# Notice of Allowability

10/801,790

BORGERSON ET AL.

The prior art of record fails to show or render obvious a torque-to-thrust apparatus as defined in claim 1, particularly wherein a friction means is disposed between the stationary component and a member of the one-way torque-transmitting mechanism to hold the one-way torque-transmitting mechanism member stationary to inhibit the reverse rotation of the rotary input member in a second direction until a predetermined rotary force is present at the rotary input member in the second direction.

# ANNOTATED SHEET

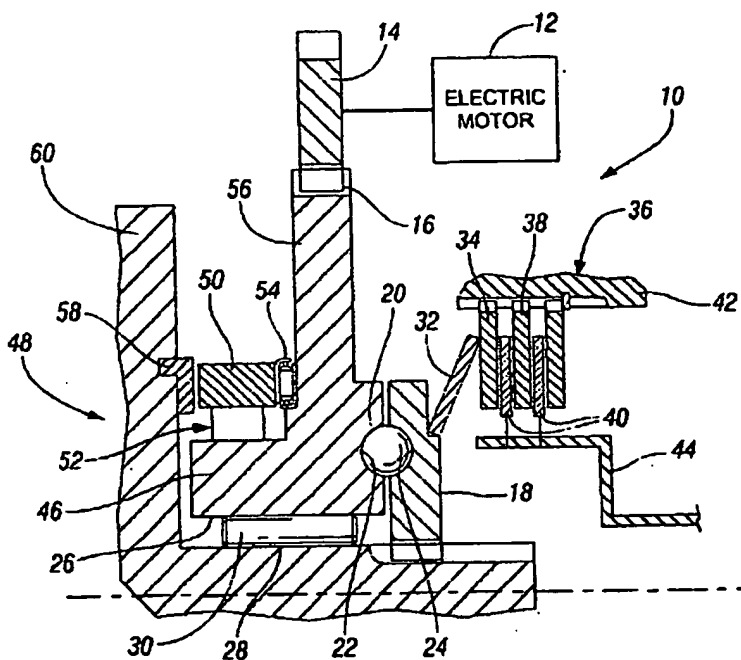
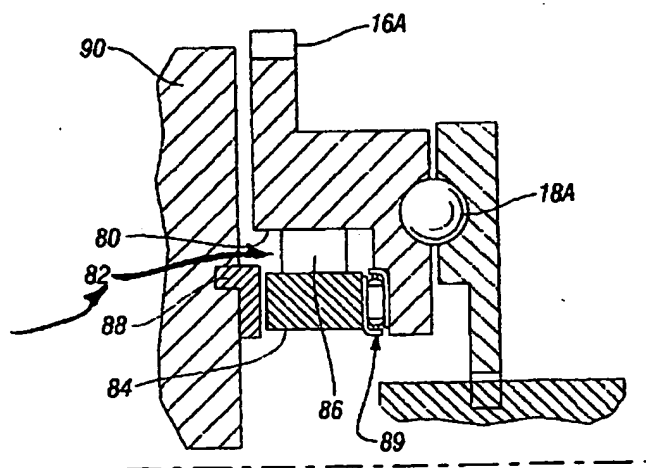
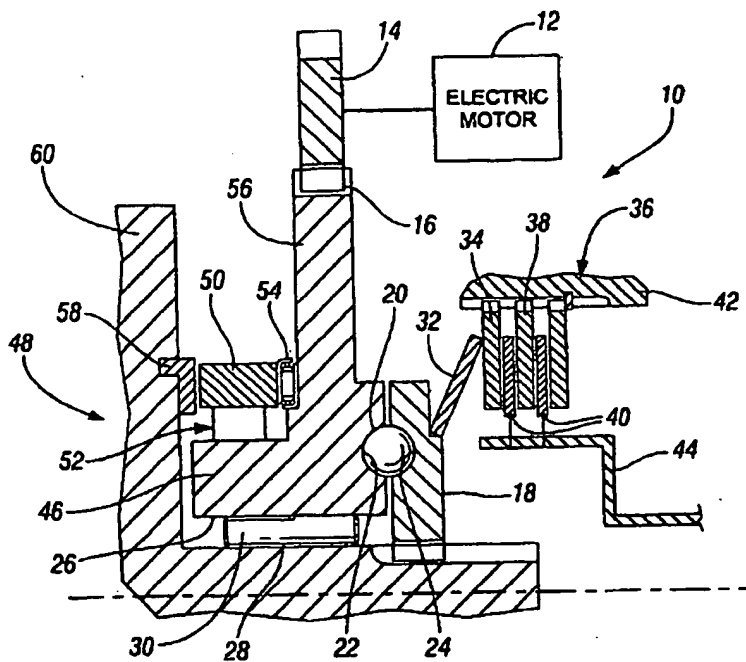
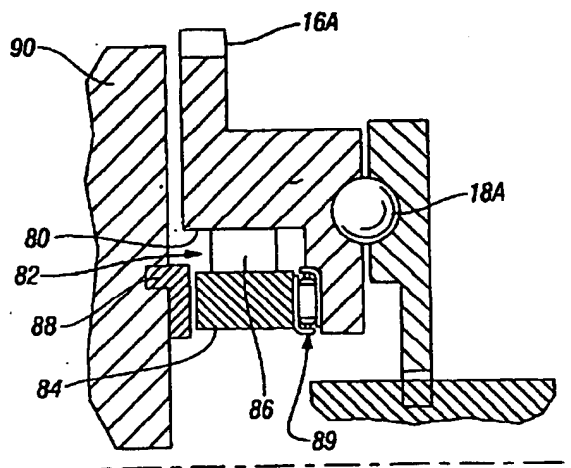
LEAD  
LINE  
ADDED

The proposed replacement sheets of drawings were received on October 27, 2005. These proposed replacement sheets are approved.

Approved  
RHB  
11/04/05
